# VILLAGE OF ELM GROVE

PLAN COMMISSION MEETING  
Monday, March 7, 2016 \* 7:00 PM \* Court Room

Re: 13400 and 13402 Watertown Plank Road  
Re-Development Concept Plan Review

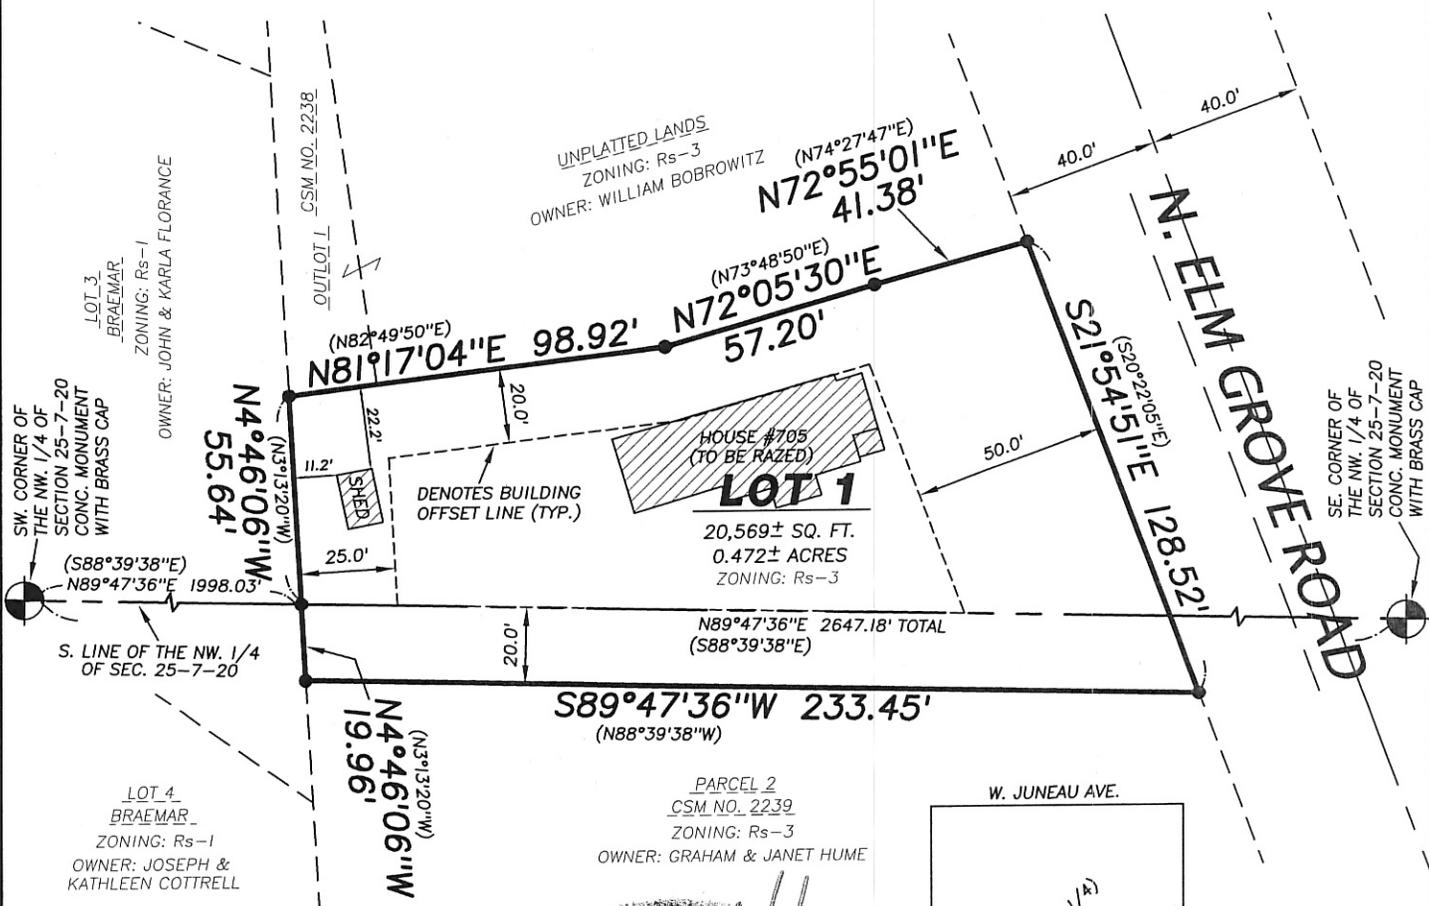
1. Per Chapter 236 (1m) (a): In the Surveyor's Certificate, Registered must be changed to Professional.
2. Per Chapter 236 (1m) (a), which references 236.20 (2) (c): The recorded as bearing and distance for the all segments of the north line of Lot 1 must be shown.
3. Per Chapter 236 (1m) (a), which references 236.20 (2) (i): The bearing reference in the lower left hand corner on Sheet 1 is incorrect.
4. Per Chapter 305-10 (8): The zoning for Lot 1 must be indicated.

**SITE PLAN**

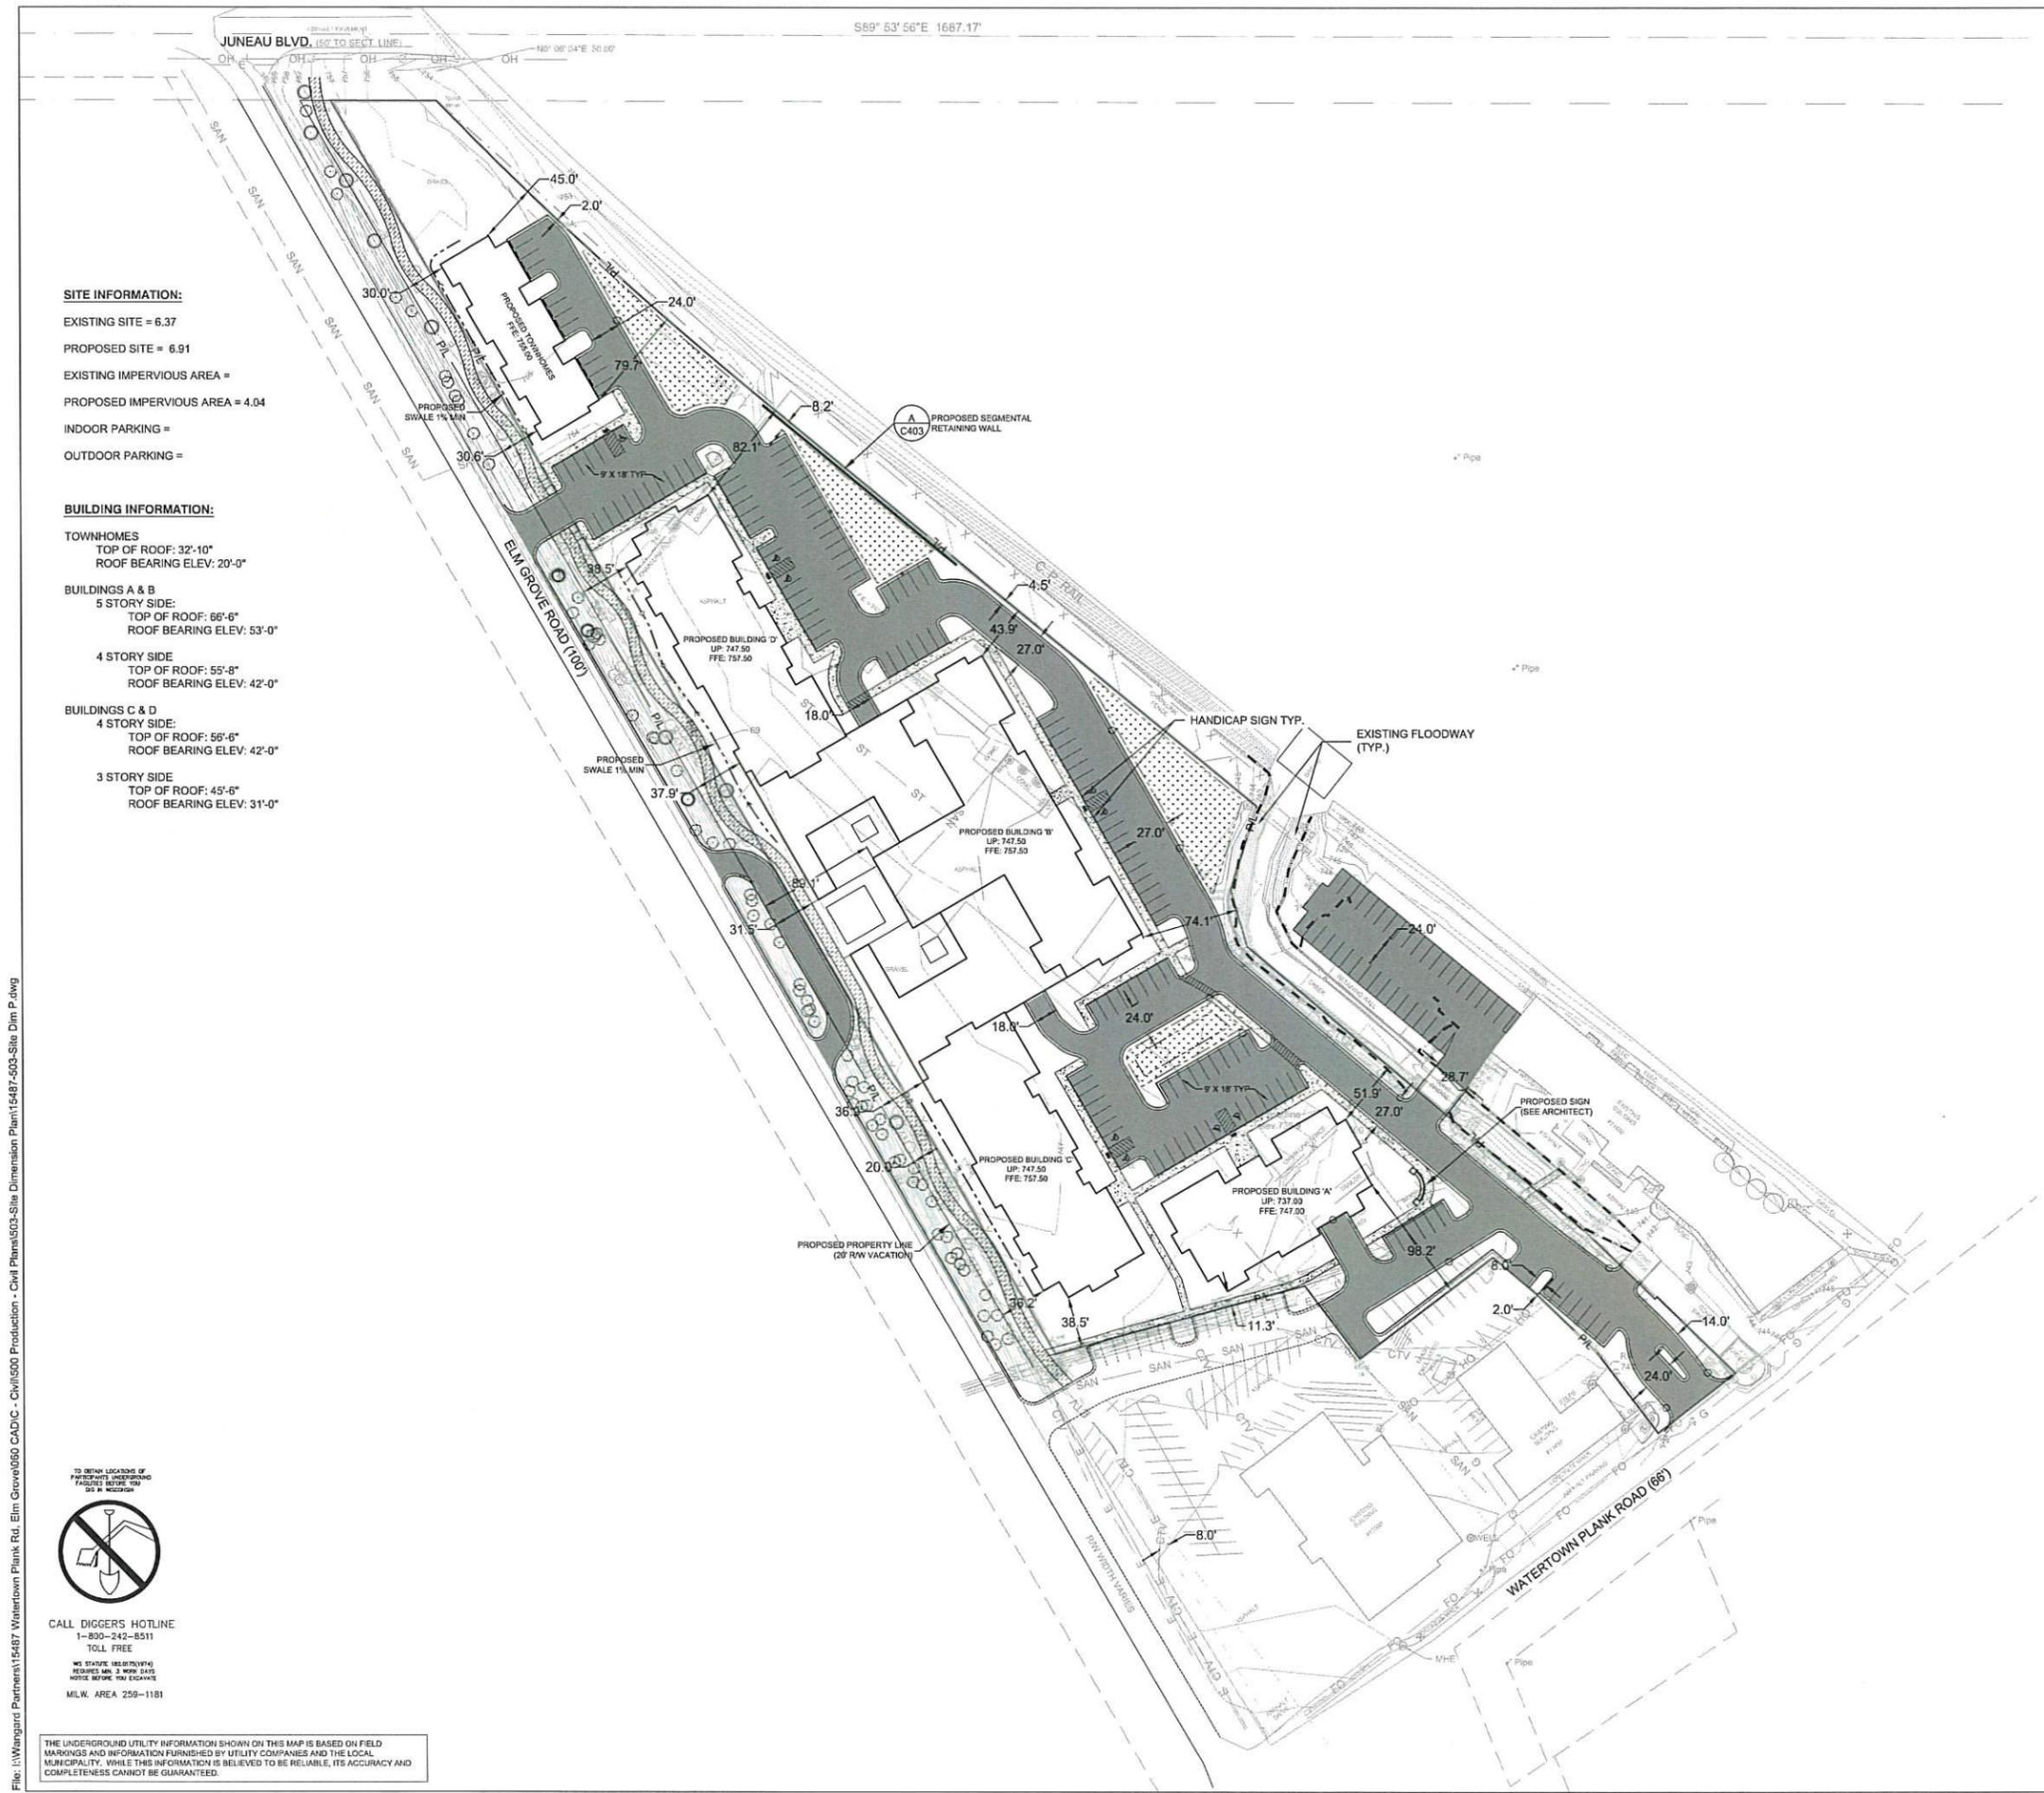
1. The Concept Plan does not show improvements to the intersection of Elm Grove Road and Juneau Boulevard as recommended in the Traffic Impact Analysis (TIA).

4. One of the recommendations in the TIA is to maintain the existing west driveway access to Watertown Plank Road with no median. The Concept Plan shows the driveway to remain, but includes a median.

10. The density of multifamily units proposed by the Concept Plan is higher than is allowed by the proposed underlying zoning. The PDO provides flexibility for the applicant to increase the density. The Concept Plan proposes a density that requires the highest degree of flexibility. We understand the Village will need to decide if the development meets the criteria to allow the proposed density level.

12. The PDO district provides flexibility to yard setbacks required by the proposed underlying RM-1 zoning. Regardless, the Concept Plan will need to provide dimensions of yard setbacks from all existing or future lot lines for review.

24. Proposed utilities on site that will be publicly owned will need to be located within easements.
25. Future designs will need to show how the southern building will be served by sanitary sewer.

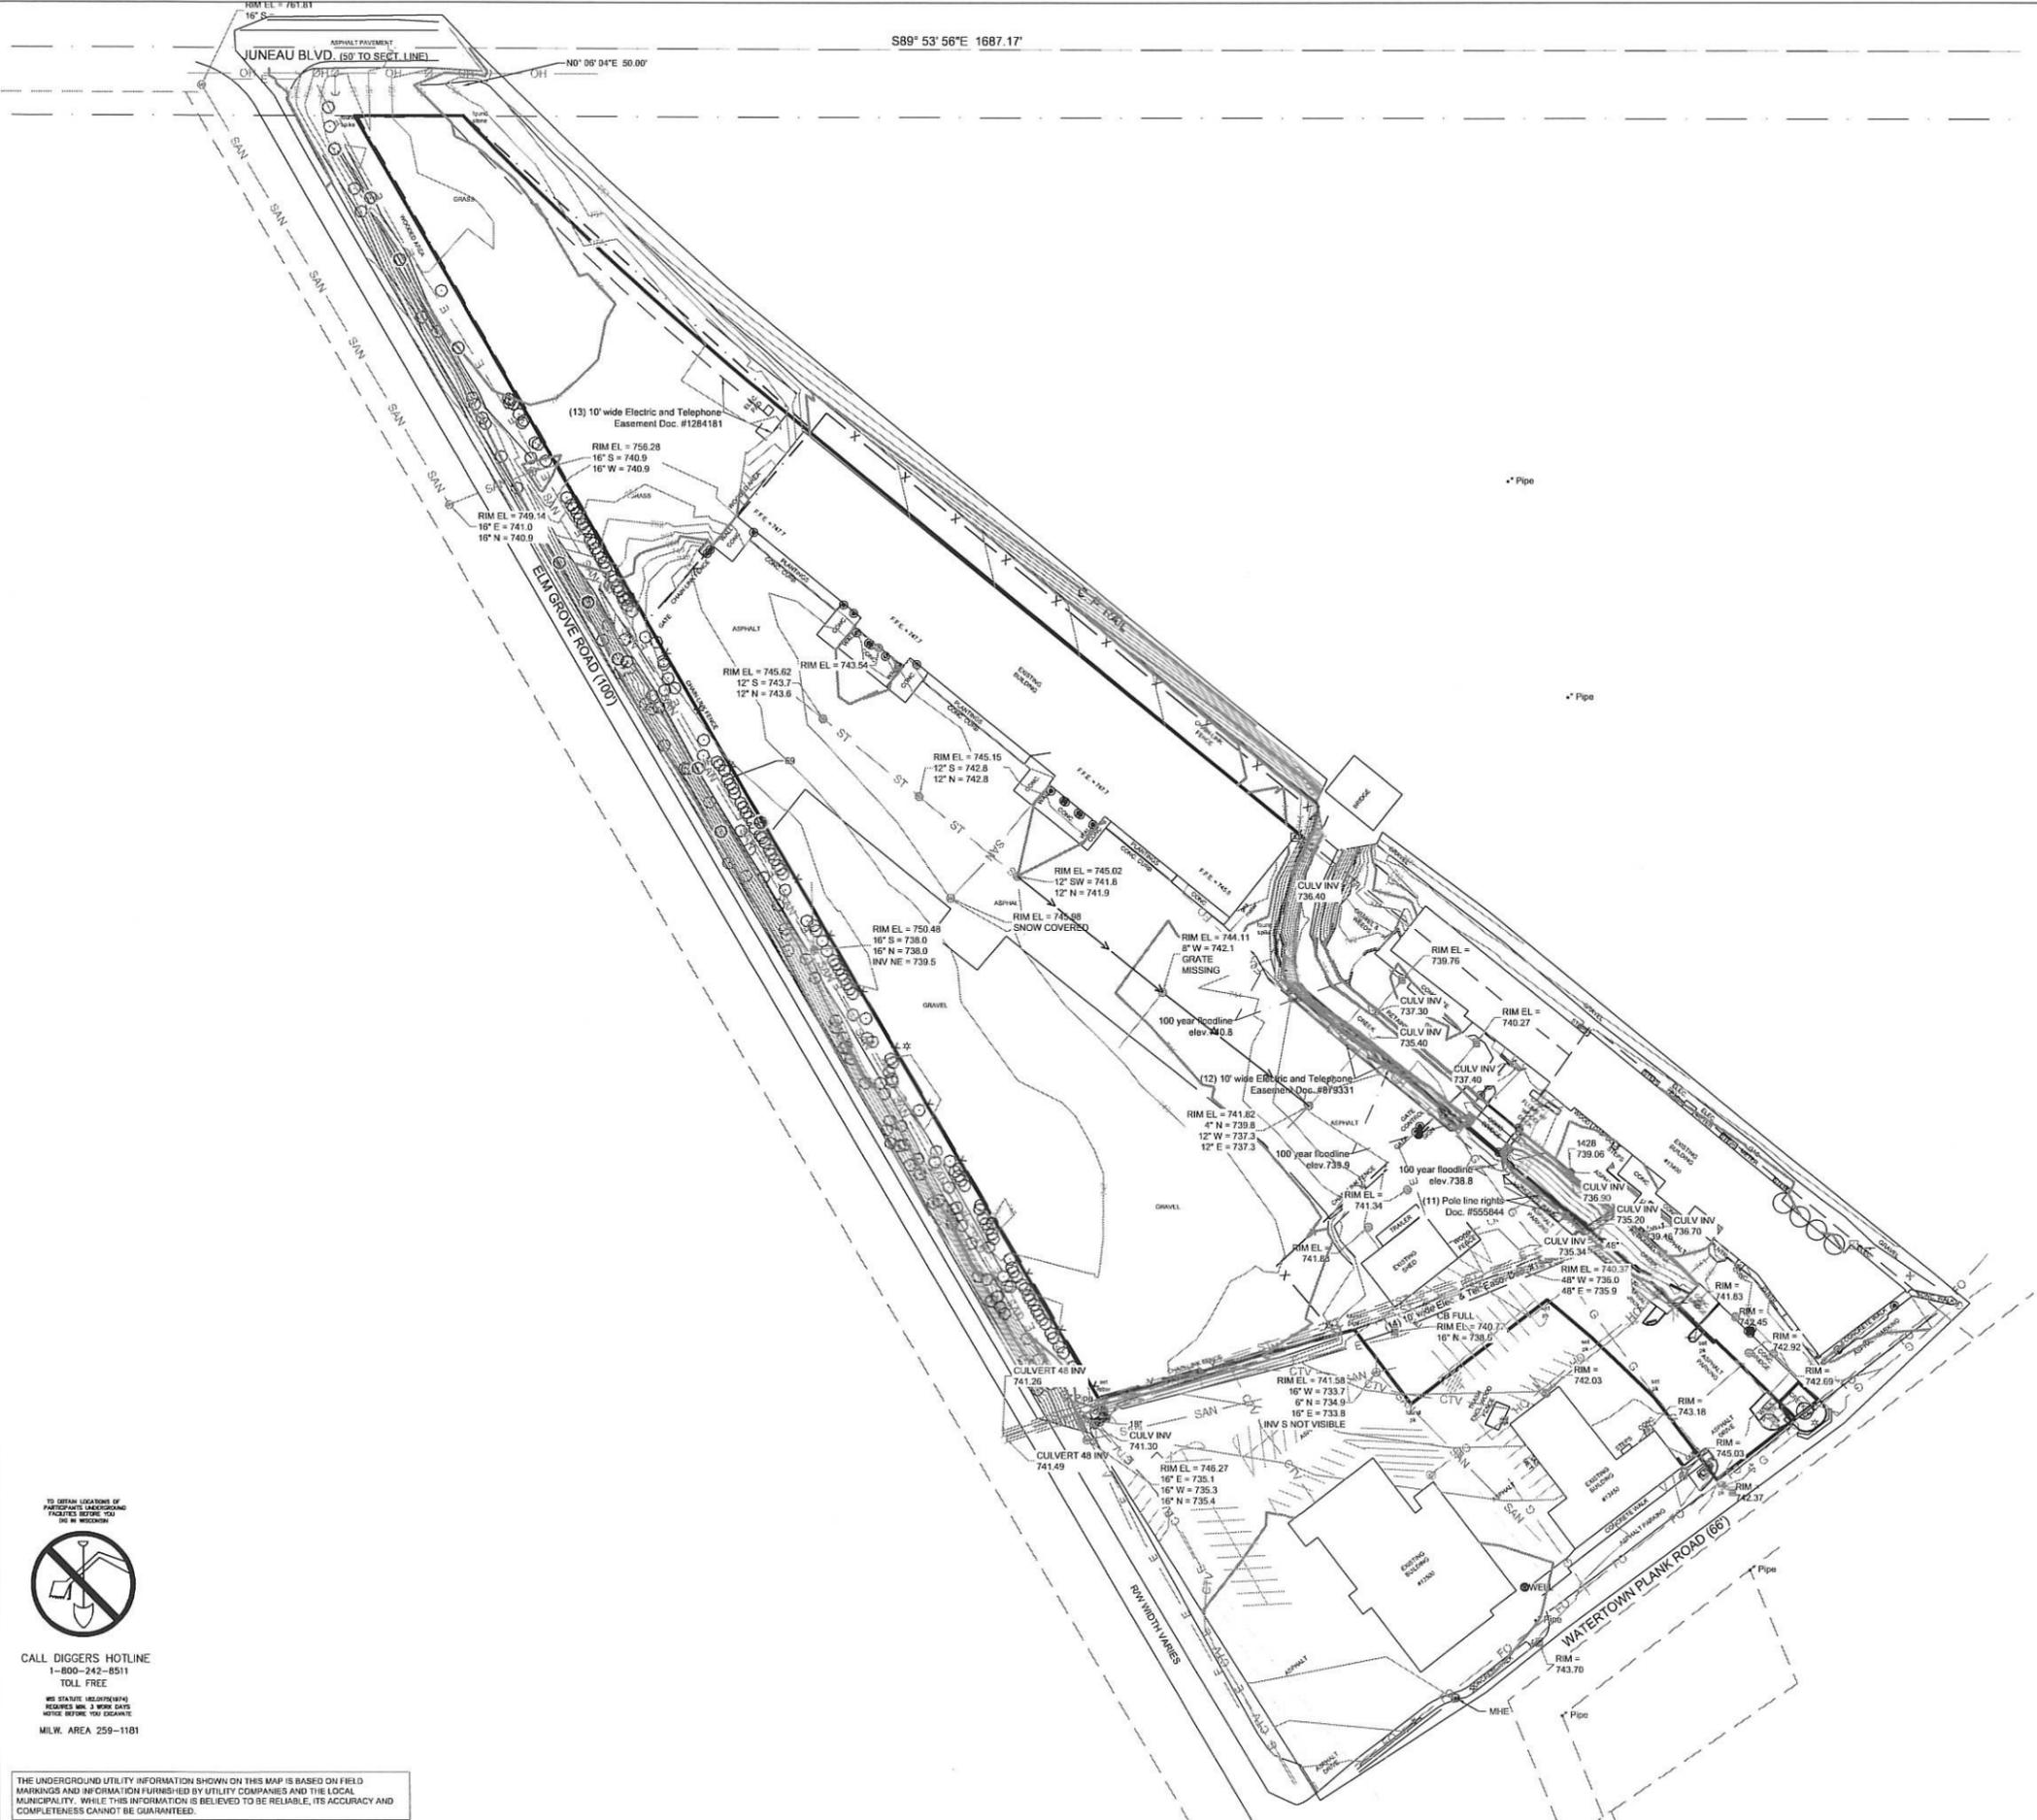
6. Re-development of Phase 1 is located on two separate parcels. A Site Survey drawing was provided with the overall Concept Plan. The drawing shows the property boundary of the larger parcel, but not the smaller one to the east. A Plat of Survey should be prepared for each parcel showing property boundary lines with distances and bearings. The Plat of Survey should also show existing site features and label proposed changes to property lines, existing easements, encumbrances, floodplains, environmental areas and other requirements listed in the Village Code. During the February 5<sup>th</sup> meeting we were told there may be a discrepancy in the boundary of the larger parcel when compared to the Waukesha County Land Information System web site. We recommended during the meeting that title reports be obtained for the parcels to help determine if any land ownership issues exist so that they can be resolved.

20. Both parcels are located adjacent to a railroad. It appears the building proposed to be removed from the smaller parcel is located within the railroad right-of-way and possibly within an easement according to the Site Survey of the Concept Plan. Work within a railroad right-of-way will require a permit from the railroad.
